SERVICE BULLETIN REVISION NOTICE

NACELLE - THRUST REVERSER – DOORS, PRESSURE RELIEF, AND LATCH ACCESS – MODIFICATION OF

Turbojet Engine Service Bulletin No. V2500-NAC-78-0114 Revision No. 3 dated May 9, 2017.

Revision 3 May 9, 2017

LATCH ACCESS DOOR SEAL ASSEMBLY AND SHIM REMOVAL
FIGURE 1

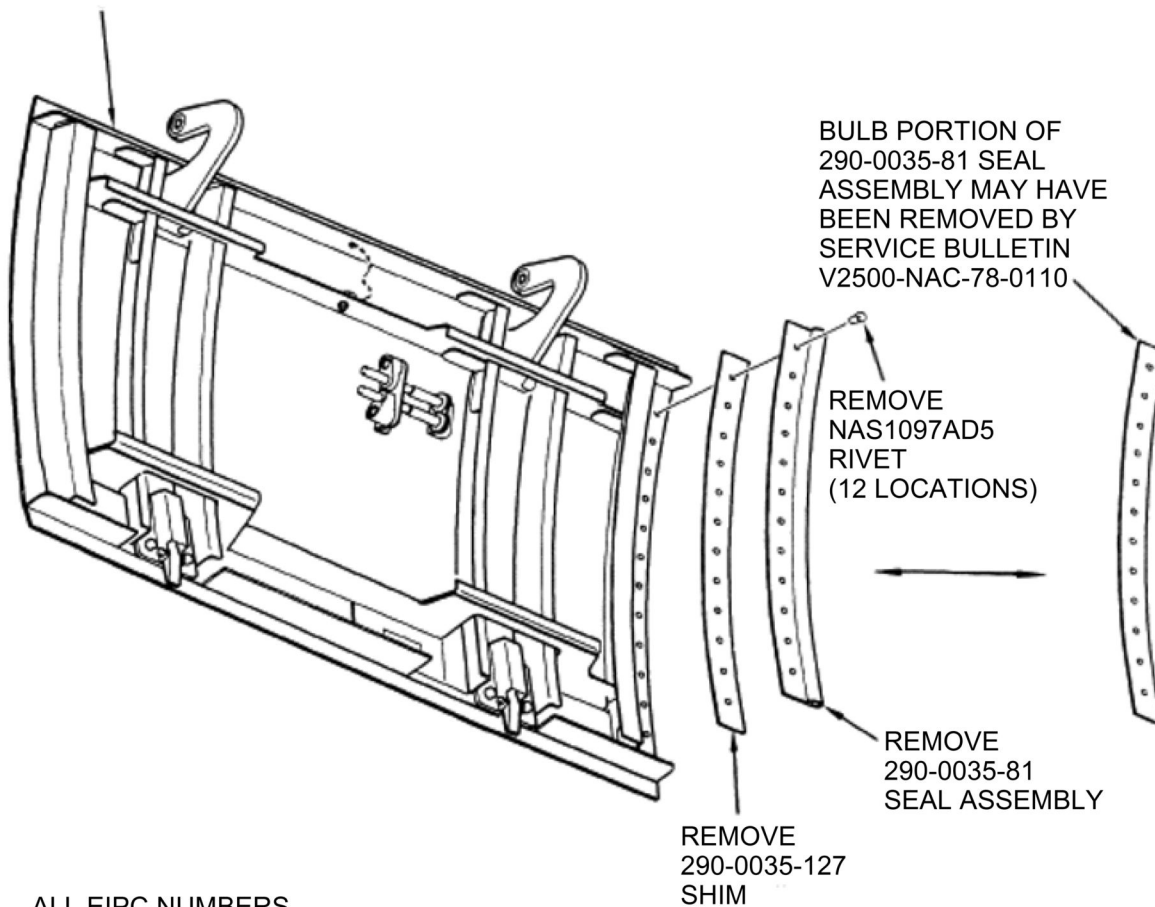
- (1) Use a 0.161 - 0.165 in. (4.089 - 4.191 mm) diameter drill to drill out the twelve (12) Rivets, PN NAS1097AD5 used to hold the Seal Assembly, PN 290-0035-81 and Shim, PN 290-0035-127 to the Latch Access Door, PN 290-0038. Remove the Seal Assembly, PN 290-0035-81 and shim from the latch access door. Do not remove the Shim, PN 290-0035-115 from the latch access door. Refer to Figure 1.
- (2) Put the Blade Seal, PN 290-0038-3 and Retainer, PN 290-0035-83 on the Latch Access Door, PN 290-0038. Hold the seal and retainer in place. Refer to Figure 2.
- (3) Use a 0.161 - 0.165 in. (4.089 - 4.191 mm) diameter drill to drill through the existing rivet holes in the Latch Access Door, PN 290-0038 and into the Blade Seal, PN 290-0038-3 and the Retainer, PN 290-0035-83. Remove burrs from drilled holes.

LATCH ACCESS DOOR BLADE SEAL AND RETAINER INSTALLATION
FIGURE 2

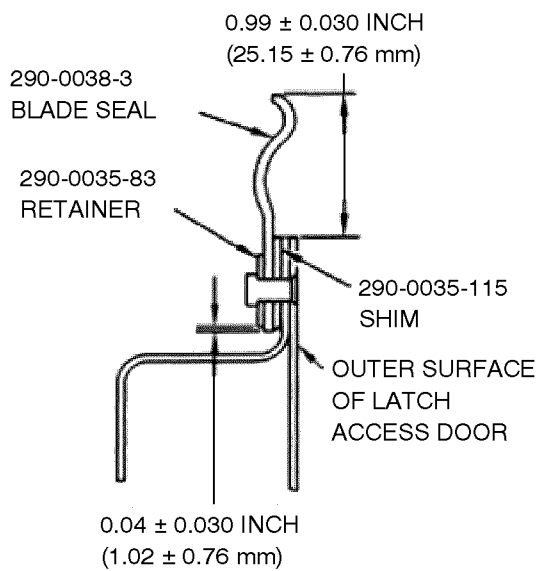
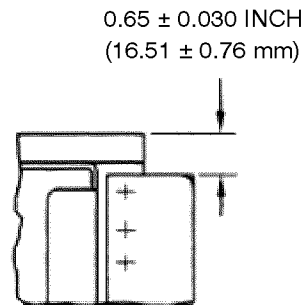
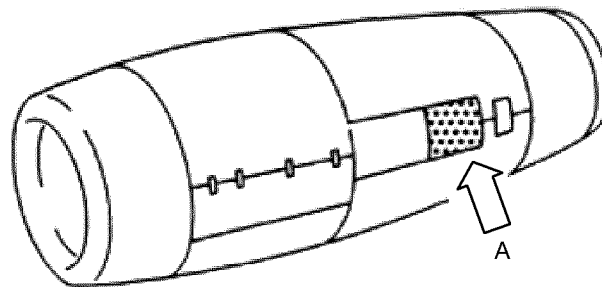
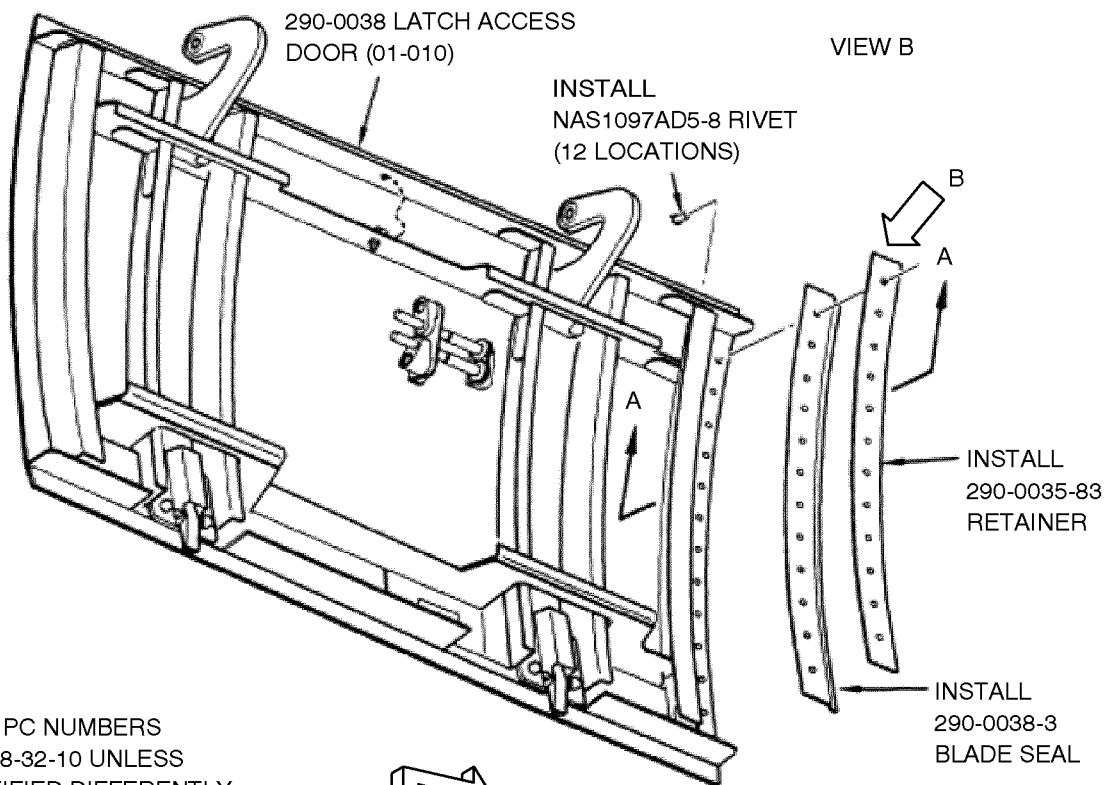
- (4) Mix Primer Base (CoMat 07-071), Primer Converter (CoMat 07-067), and Thinner (CoMat 07-066). Refer to the manufacturer's instructions.
- (5) Put the Blade Seal, PN 290-0038-3 and Retainer, PN 290-0035-83 on the Latch Access Door, PN 290-0038 and wet install the twelve (12) Rivets, PN NAS1097AD5-8 with primer mix. Wipe off any excess primer with a clean cloth.

PRESSURE RELIEF DOOR ASSEMBLY LATCH CAM MODIFICATION
FIGURE 3

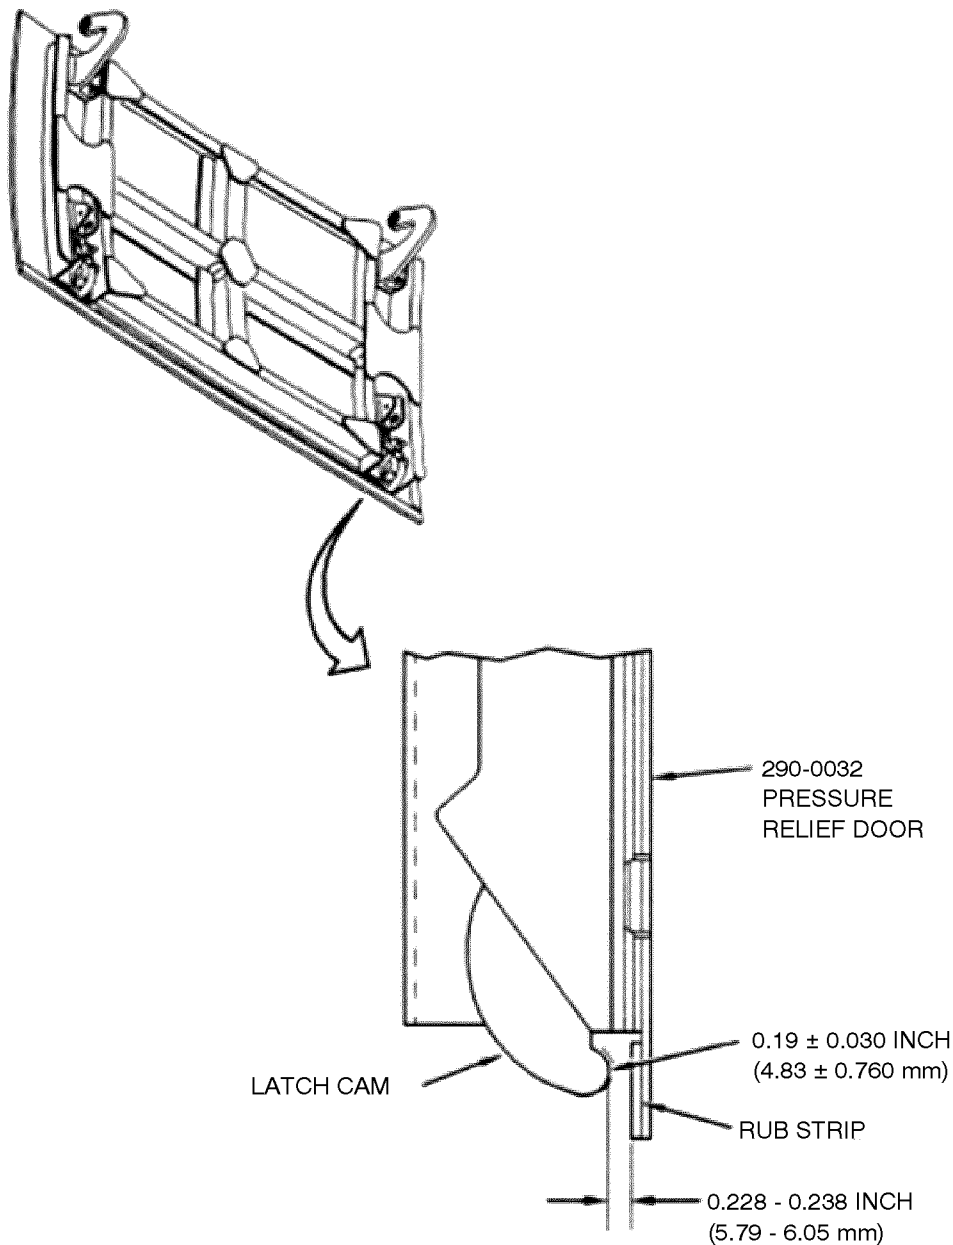
- (5) The Material Information section has been changed and rewritten.
- (6) To add latch assembly PN to Accomplishment Instructions section 2.B.
- (7) To change gap dimension in Figure 3 to agree with engineering.

- (1) Measure and make a note of the distance between the pressure relief door latch cam and the rub strip in the latch closed position. Refer to Figure 3. If the measurement is not the same as the dimension shown in Figure 3, perform steps 2.B.(2) thru 2.B.(4) below. If the measurement is the same as the dimension shown in Figure 3, go to step 2.C. below.
- (2) Hand grind the latch cam with non-metallic abrasive to get the dimension shown in Figure 3.
- (3) Remove metal chips or other unwanted material with a dry air supply.
- (4) Clean the latch cam with a Clean Cloth (CoMat 02-099) and Trichloroethane (CoMat 01-001). Wipe the surface dry before solvent becomes dry.

PRESSURE RELIEF DOOR ASSEMBLY RUB STRIP REMOVAL
FIGURE 4

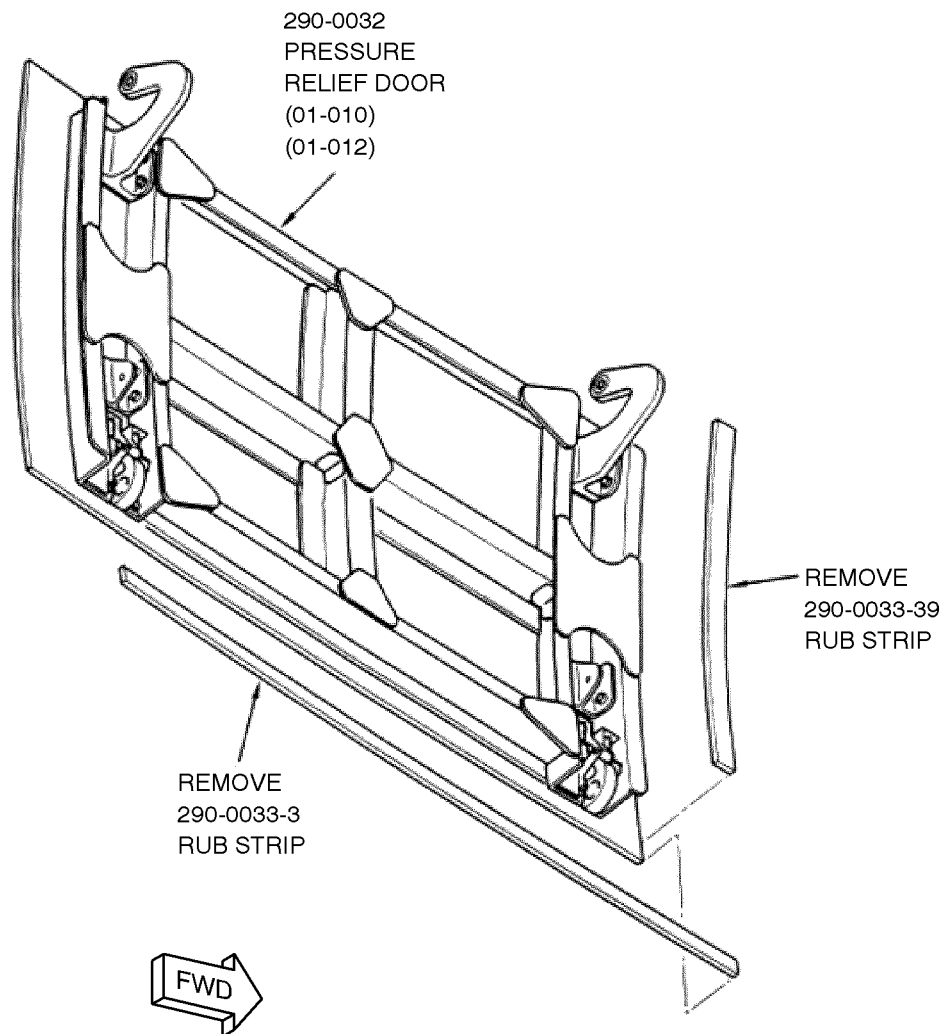
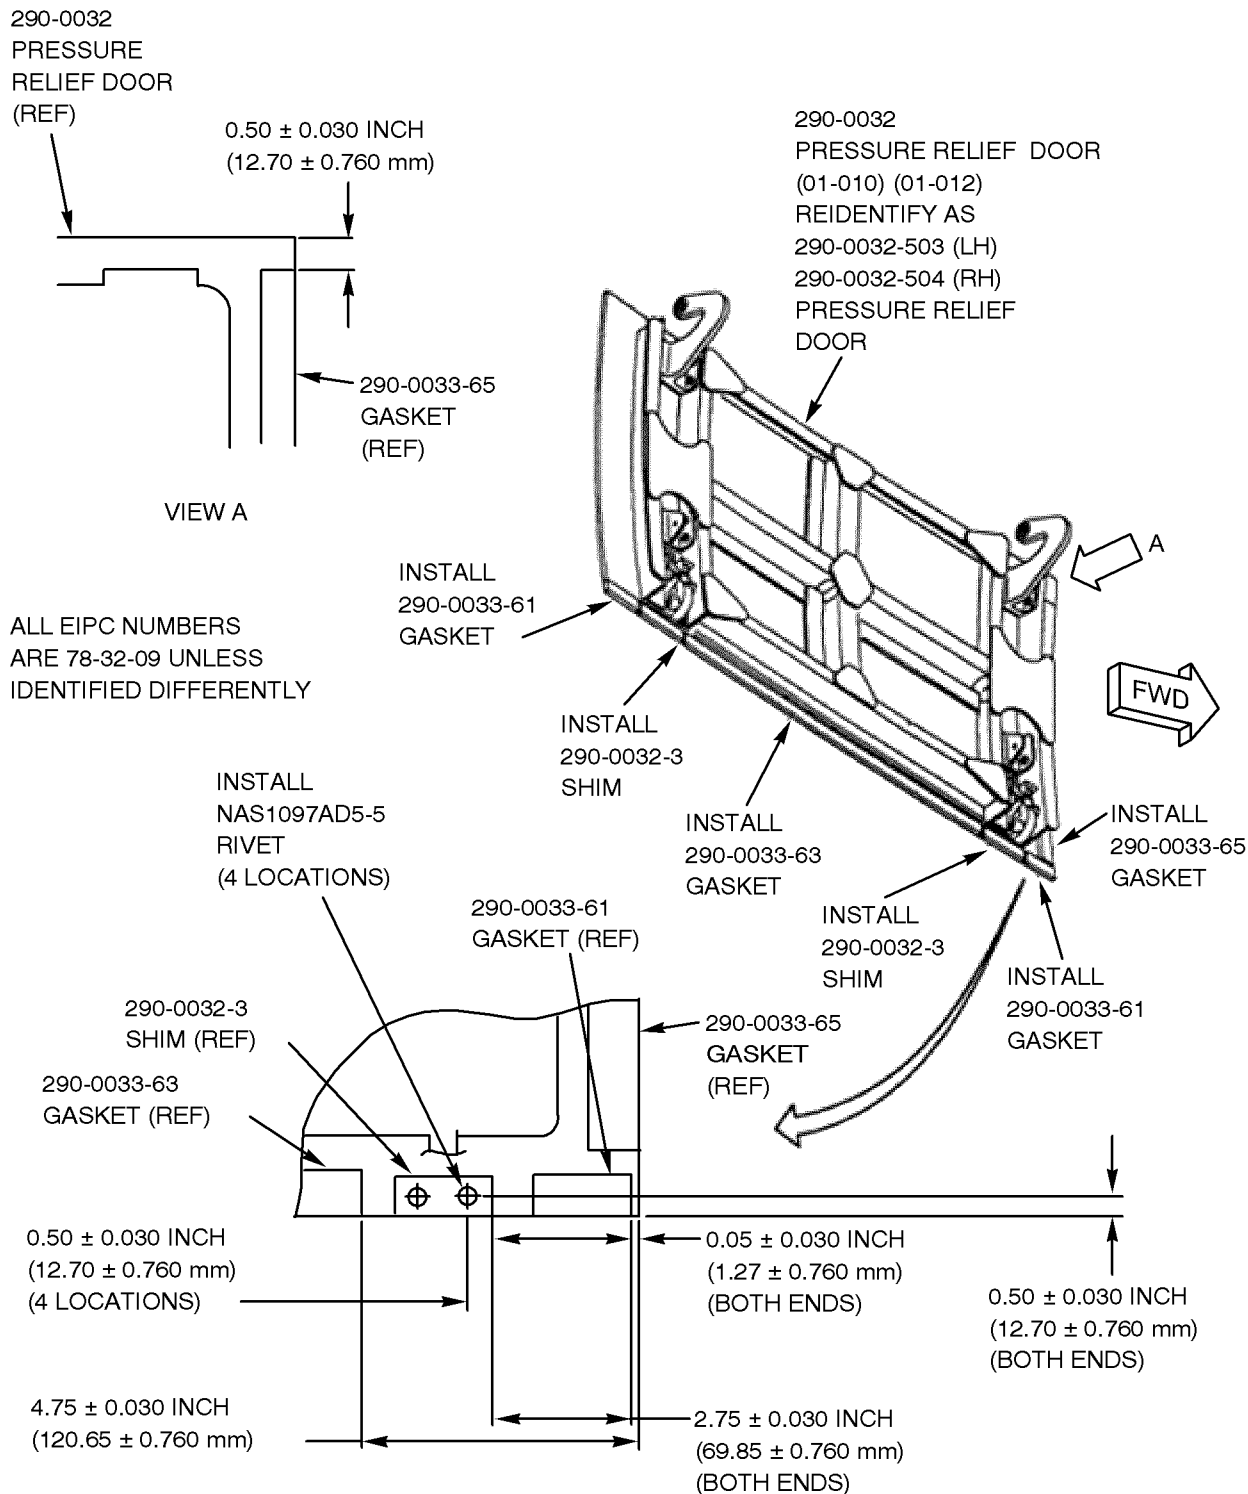
- (1) Remove the Rub Strips PN 290-0033-3 and PN 290-0033-39 from the Pressure Relief Door Assembly, PN 290-0032. Refer to Figure 4.
- (2) Remove any remaining rub strip and/or rub strip adhesive residue from the pressure relief door assembly.
- (3) With a Clean Cloth (CoMat 02-099) and Trichloroethane (CoMat 01-001), clean the rub strip mounting surfaces on the Pressure Relief Door Assembly, PN 290-0032. wipe the solvent before it becomes dry.
- (4) If bare metal was exposed on the pressure relief door when you removed the rub strip, apply chemical conversion coating and primer to the area of bare metal.

PRESSURE RELIEF DOOR ASSEMBLY SHIM AND GASKET INSTALLATION
FIGURE 5 (SHEET 2)

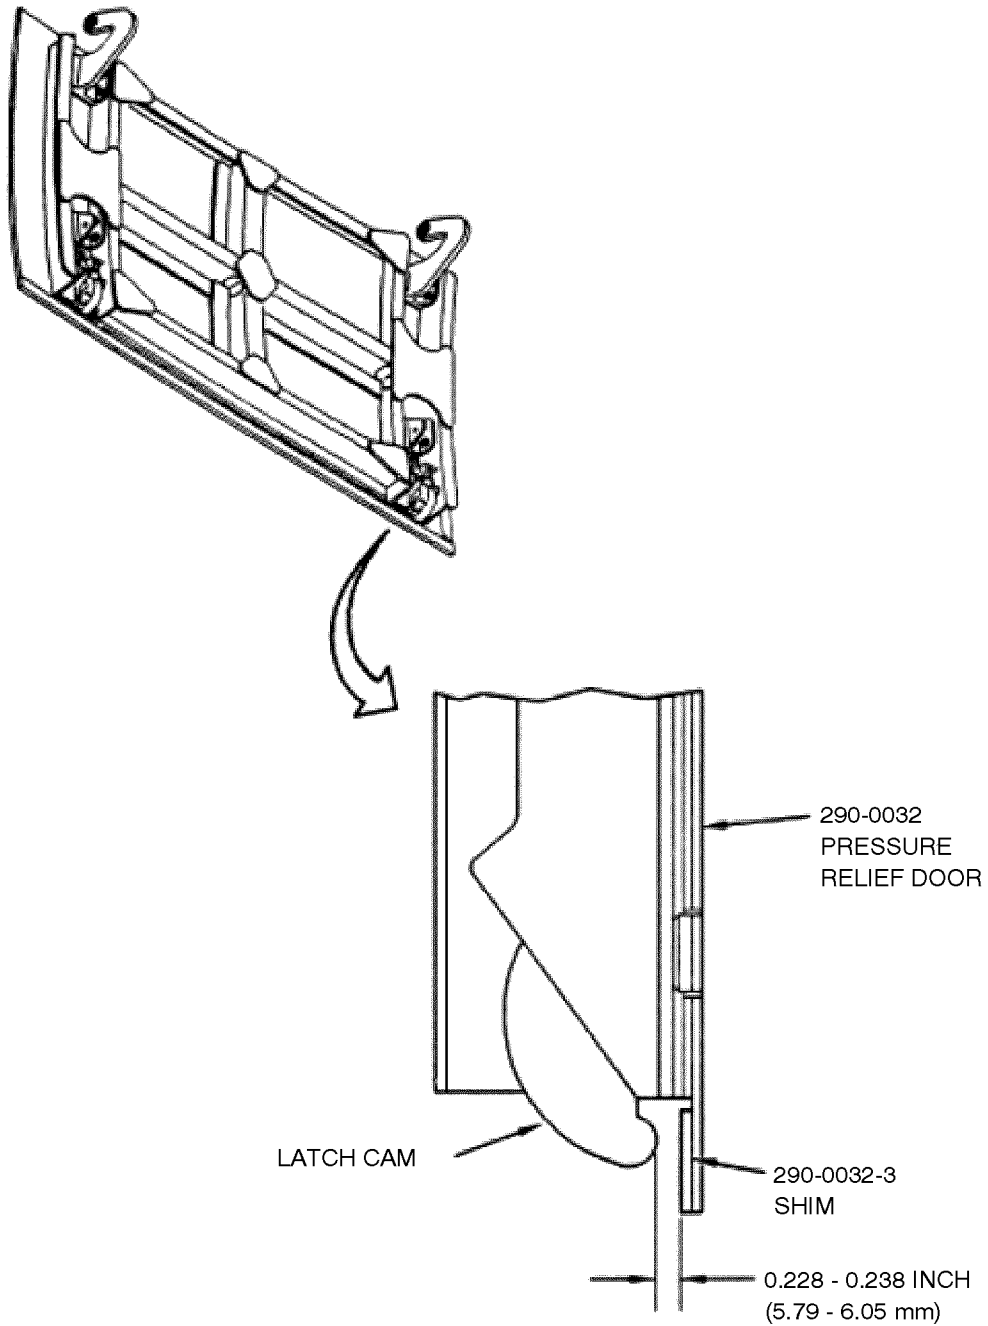
- (8) To correct Figure 3 reference in Accomplishment Instructions section 2.C.(6) to Figure 5 (Sheet 2).
- (9) To change the Accomplishment Instructions. To add NOTE eliminating the requirement to replace the pressure relief door lanyards per section 2.D. of this Service Bulletin.

- (6) Measure and make a note of the distance between the pressure relief door latch cam and the shims. Remove laminations from the shims as necessary to make a 0.228 - 0.238 in. (5.79 - 6.05 mm) space between the latch cam and the shim as shown in Figure 5 (Sheet 2).

STRIKER PLATE INSTALLATION
FIGURE 6

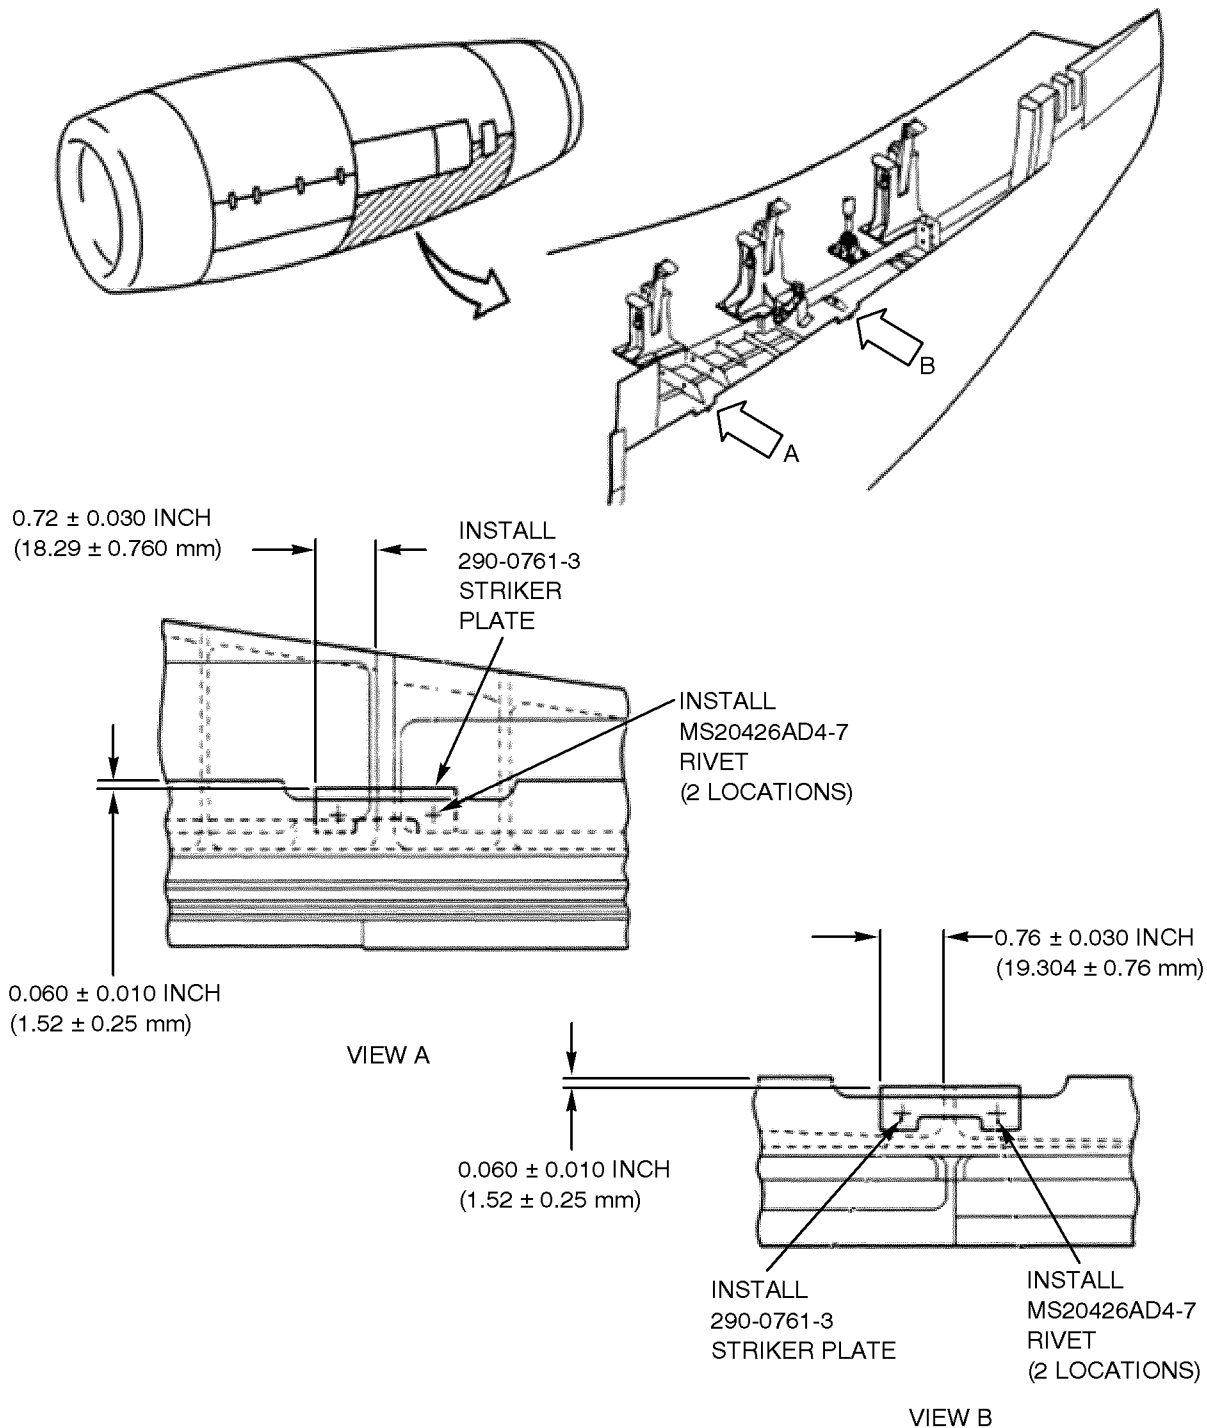
- E. Install the pressure relief door Striker Plates, PN 290-0761-3 on the lower outboard track assembly.
 - (1) Find the two notches for the pressure relief door latches on the Lower Outboard Track Assembly, PN 290-0761. Refer to Figure 6.

- (2) Put the two (2) pressure relief door Striker Plates, PN 290-0761-3 on the Lower Outboard Track Assembly, PN 290-0761 behind the notches. Hold the plates in the position as shown in Figure 6.

- (8) Make sure the 0.050 - 0.070 in. (1.27 - 1.78 mm) dimension in view B of Figure 6 is the same after you install the rivets. If necessary, remove material from the pressure relief door striker plate to get the proper dimension.
